ADDENDUM NO. 1

Date of Addendum: October 13, 2015

PROJECT NAME: Rehabilitation of Distribution Pumps, Motors, Valves, Piping and  
Pump Station Buildings at Various Facilities - Package B

PROJECT NO: WBS No. S-001000-0046-4

REHABILITATION OF PUMPS,  
 MOTORS, VALVES, PIPING &  
 BUILDINGS AT VARIOUS FACILITIES  
 PACKAGE B  
 SHARPSTOWN #1  
 BUILDING  
 HVAC PLAN

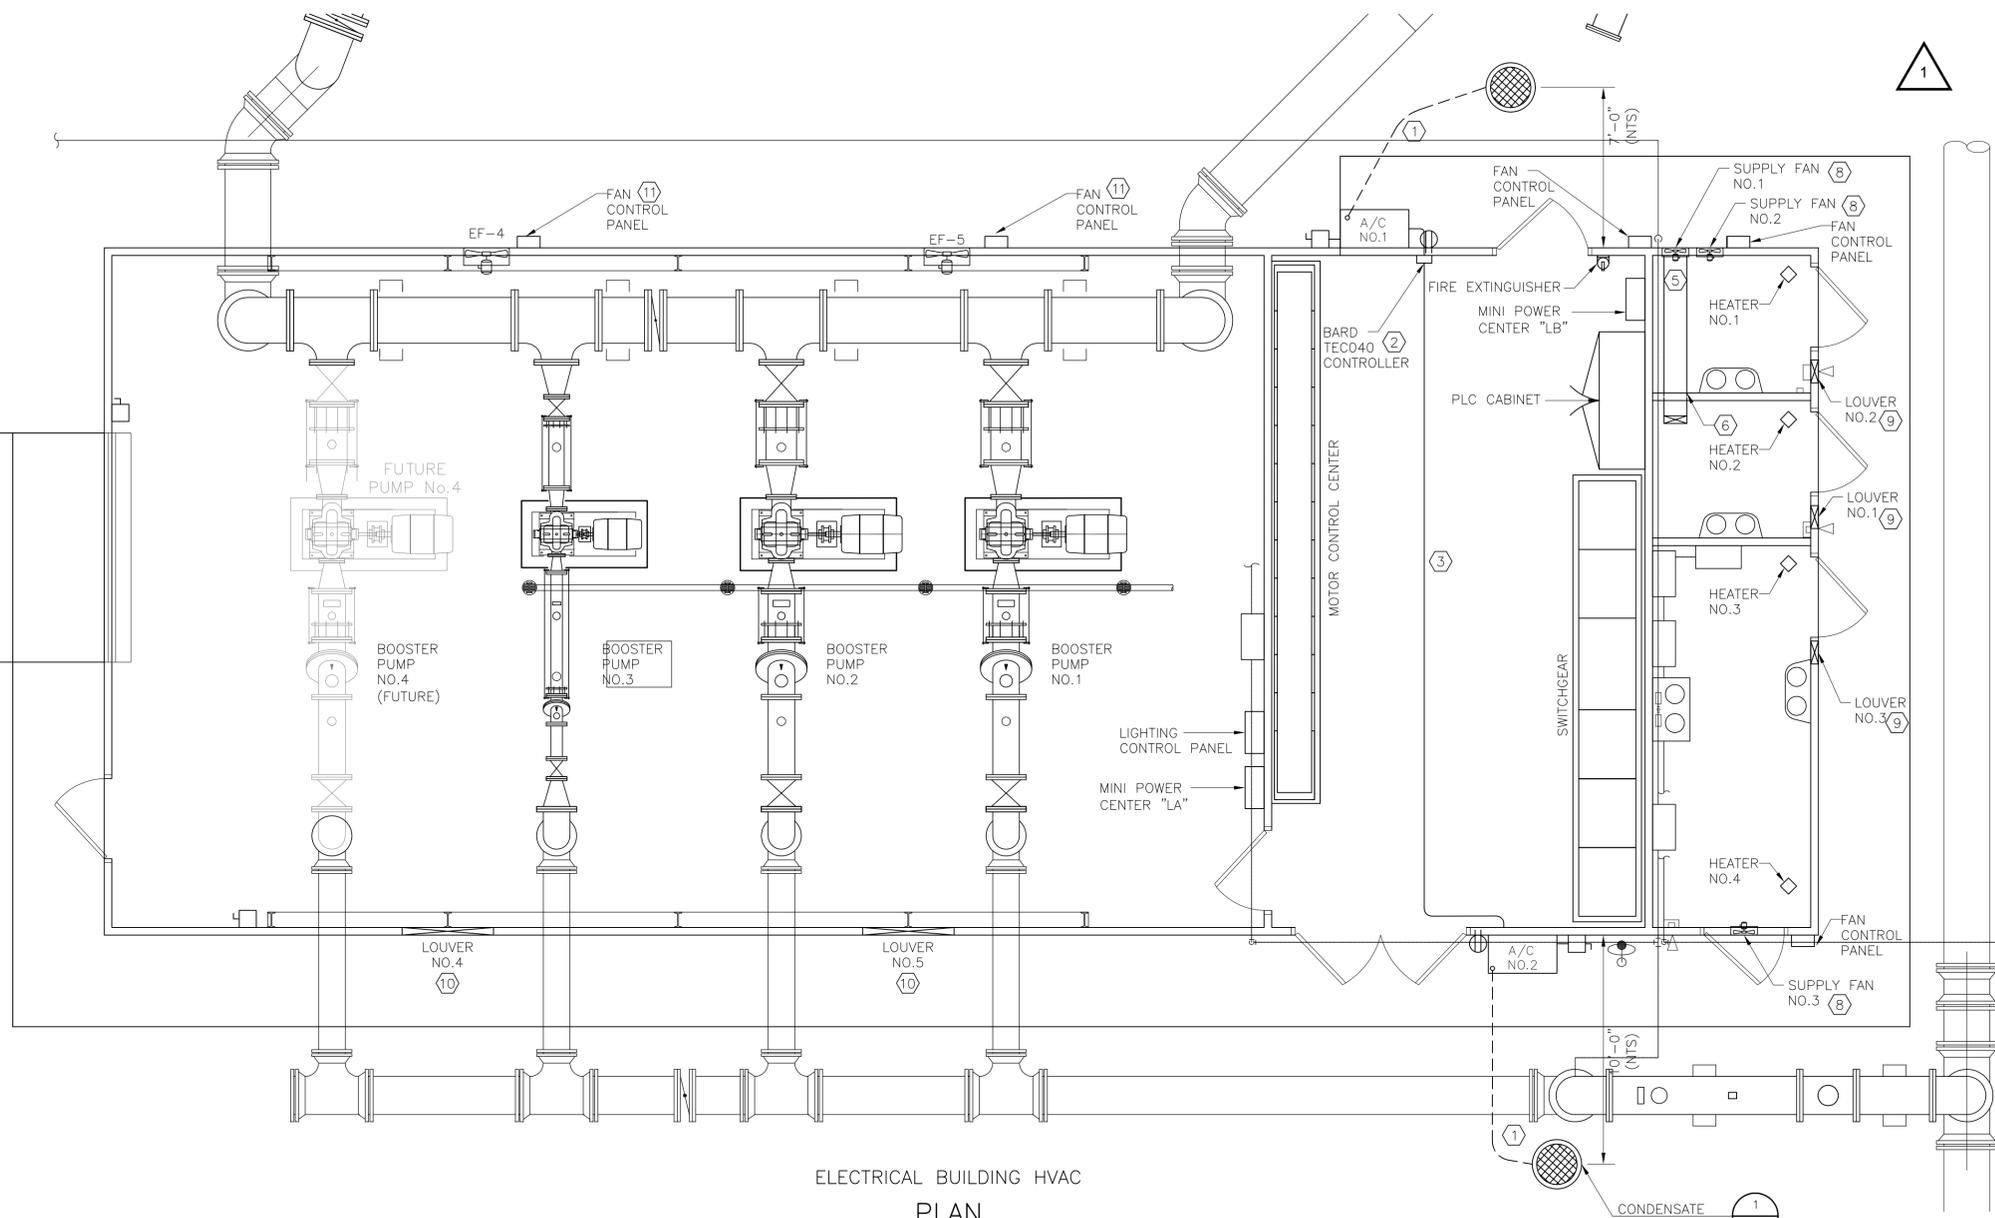
16. Delete Sheet 112 (SH#1-M-1), Booster Pumps and Piping Demolition Plan, and replace with revised Sheet 112 (SH#1-M-1).
17. Delete Sheet 117 (SH#1-H-1), Building HVAC Plan, and replace with revised Sheet 117 (SH#1-H-1).

SH#1-E-4      SHEET No. 121 OF 139

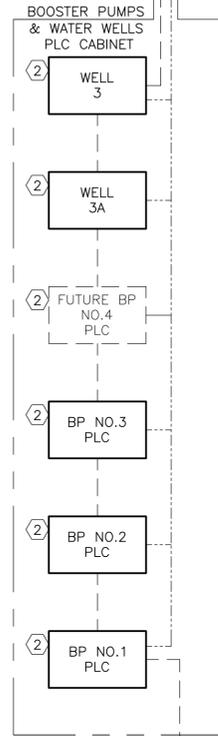
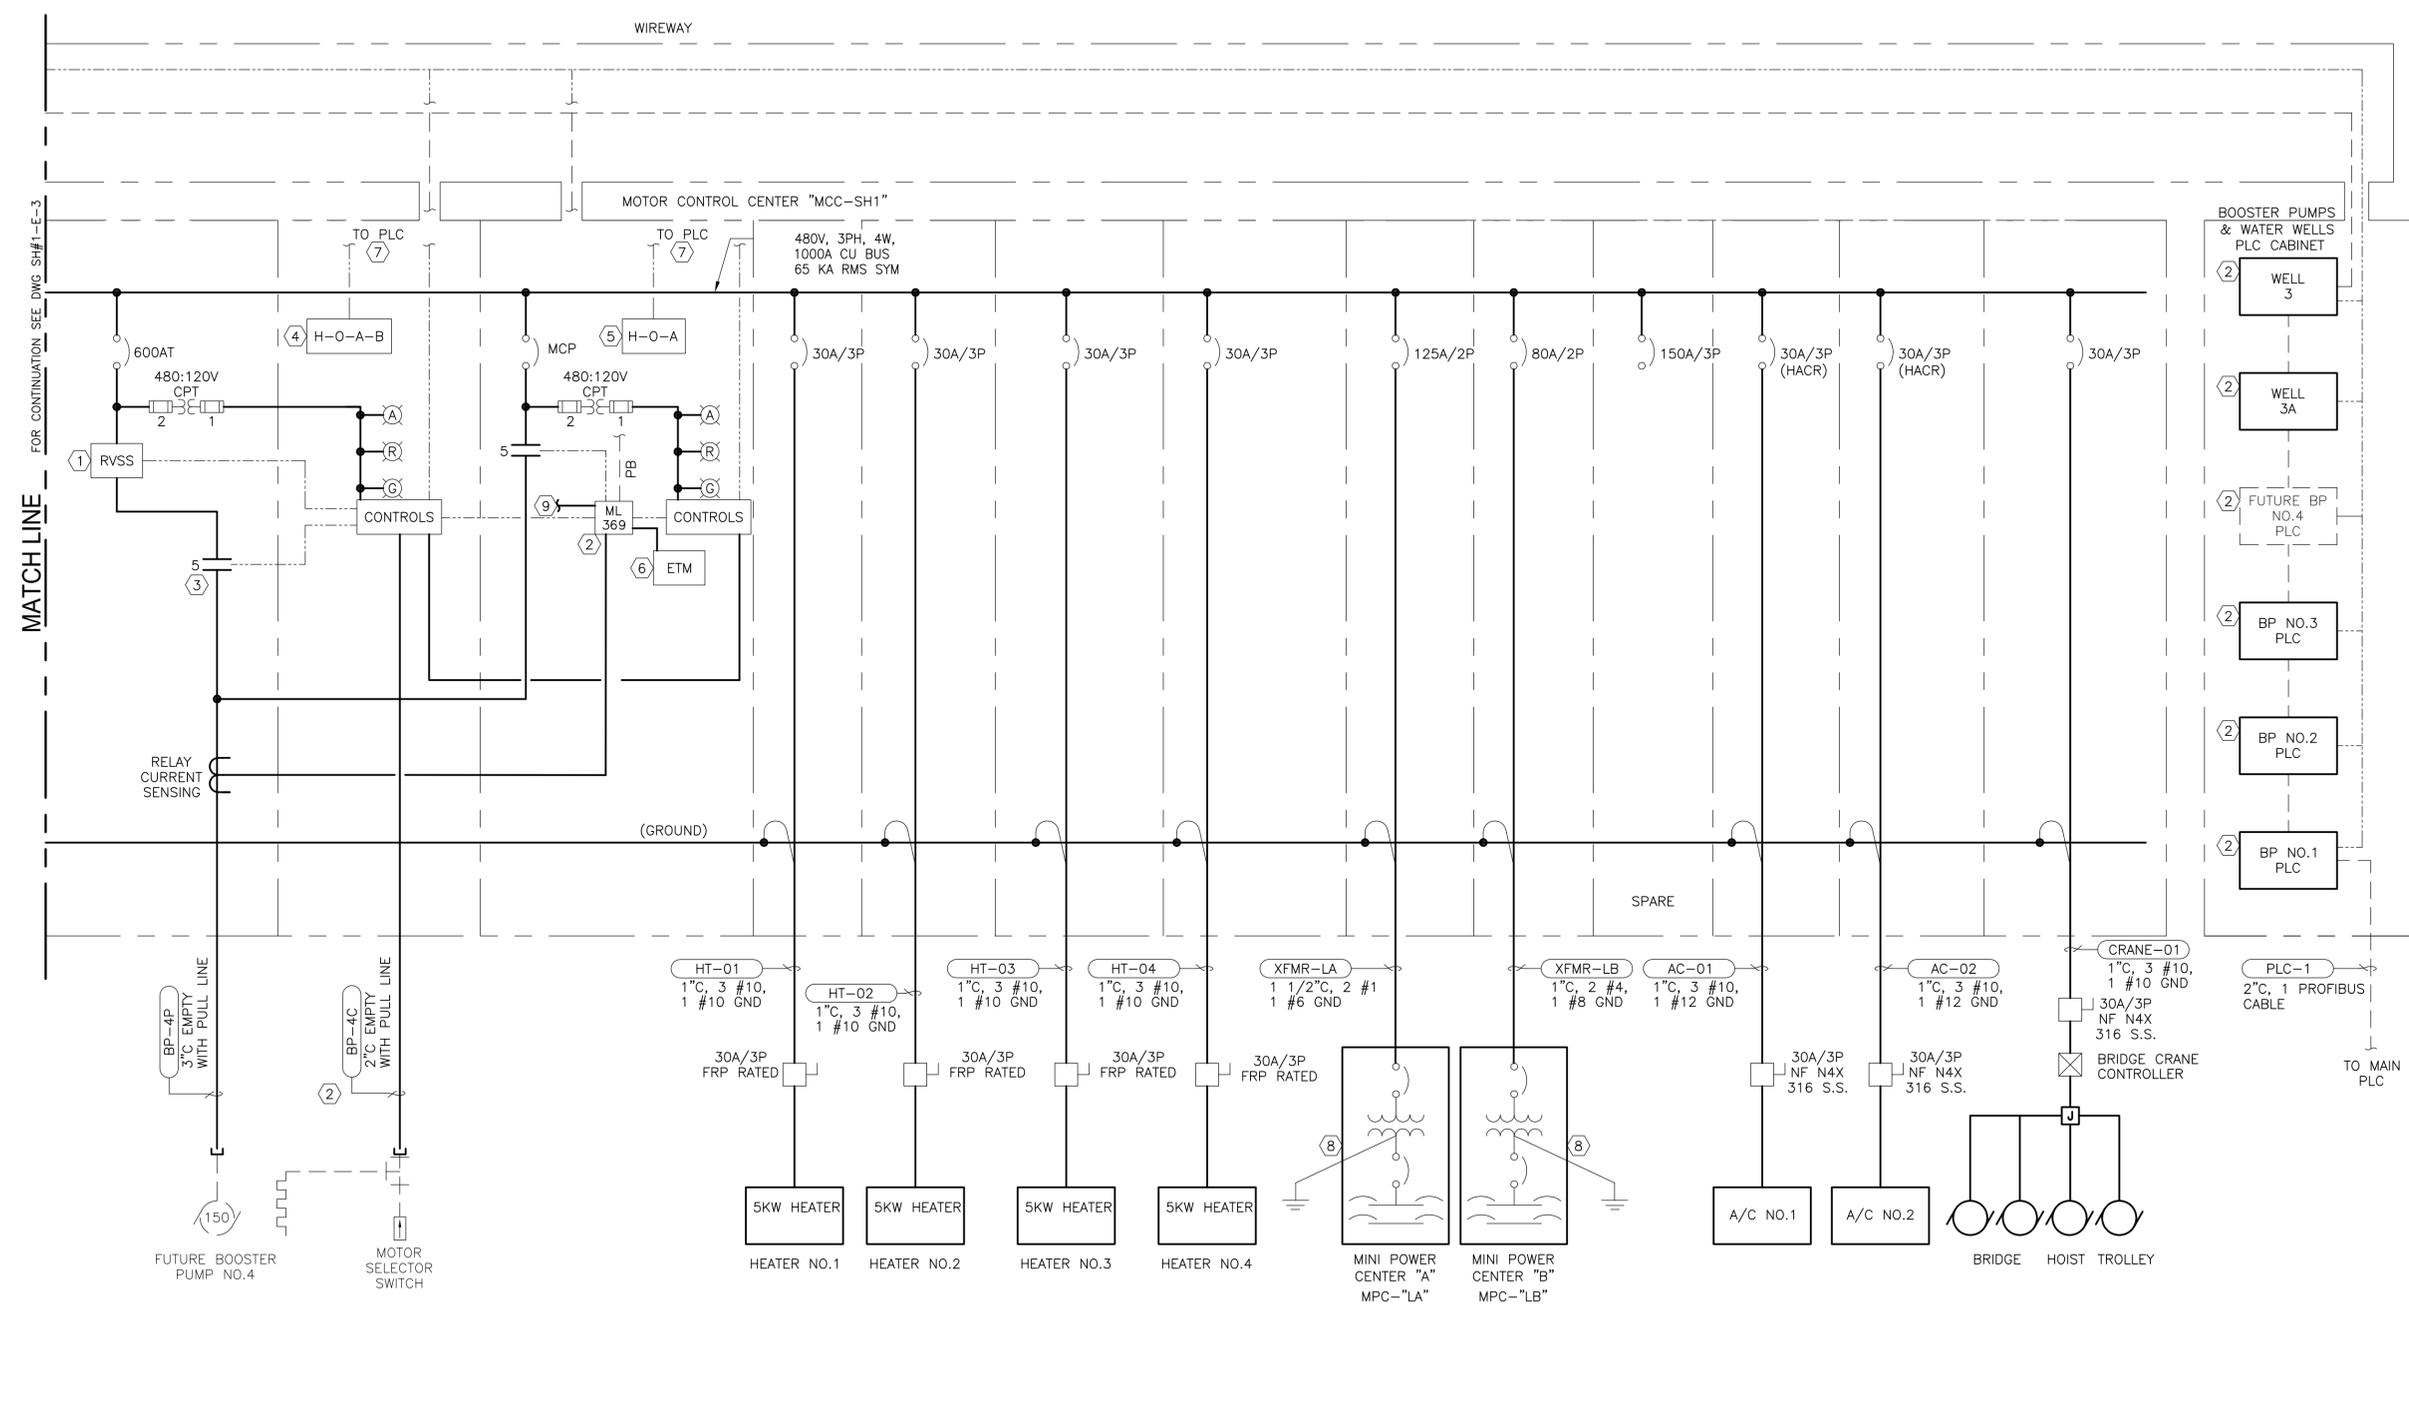
18. Delete Sheet 121 (SH#1-E-4), Proposed One Line Diagram Sheet 3 of 3, and replace with revised Sheet 121 (SH#1-E-4).
19. Delete Sheet 124 (SH#1-E-7), Building Equipment Plan, and replace with revised Sheet 124 (SH#1-E-7).

**CITY OF HOUSTON**  
 DEPARTMENT OF PUBLIC WORKS AND ENGINEERING  
**REHABILITATION OF PUMPS,  
 MOTORS, VALVES, PIPING &  
 BUILDINGS AT VARIOUS FACILITIES  
 PACKAGE B**  
**SHARPSTOWN #1  
 BUILDING  
 POWER PLAN**  
 ELECTRICAL

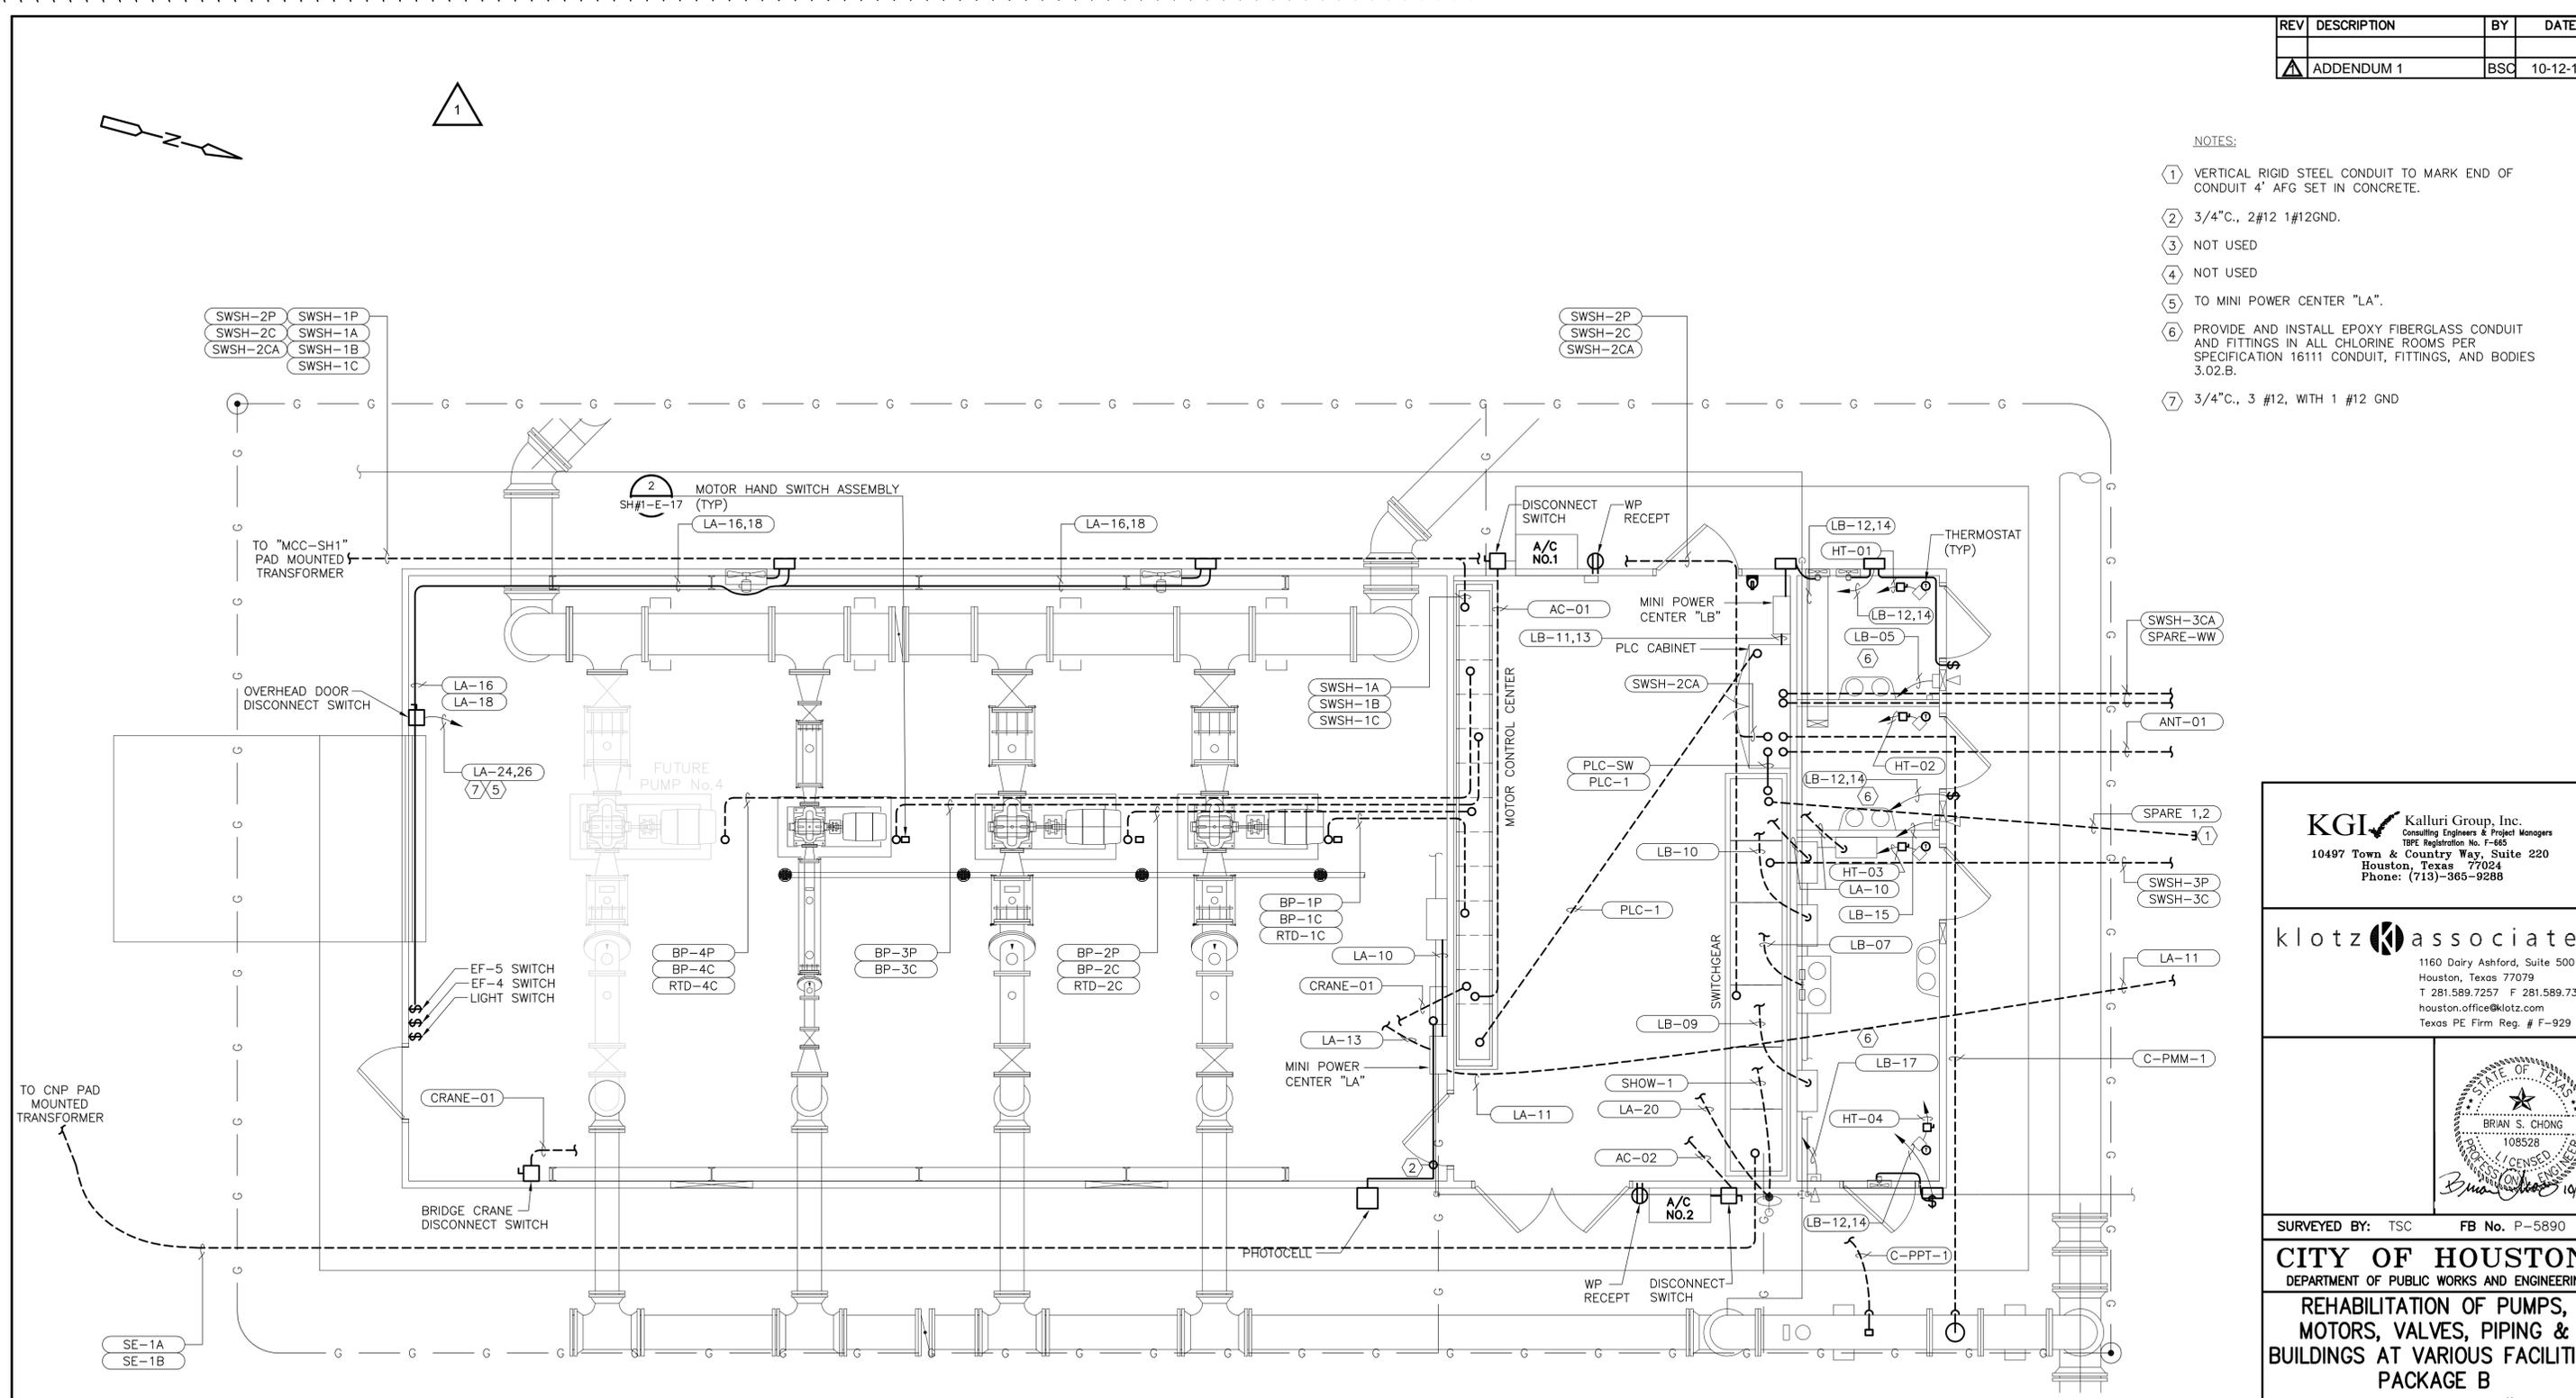
20. Delete Sheet 126 (SH#1-E-9), Building Power Plan, and replace with revised Sheet 126 (SH#1-E-9).
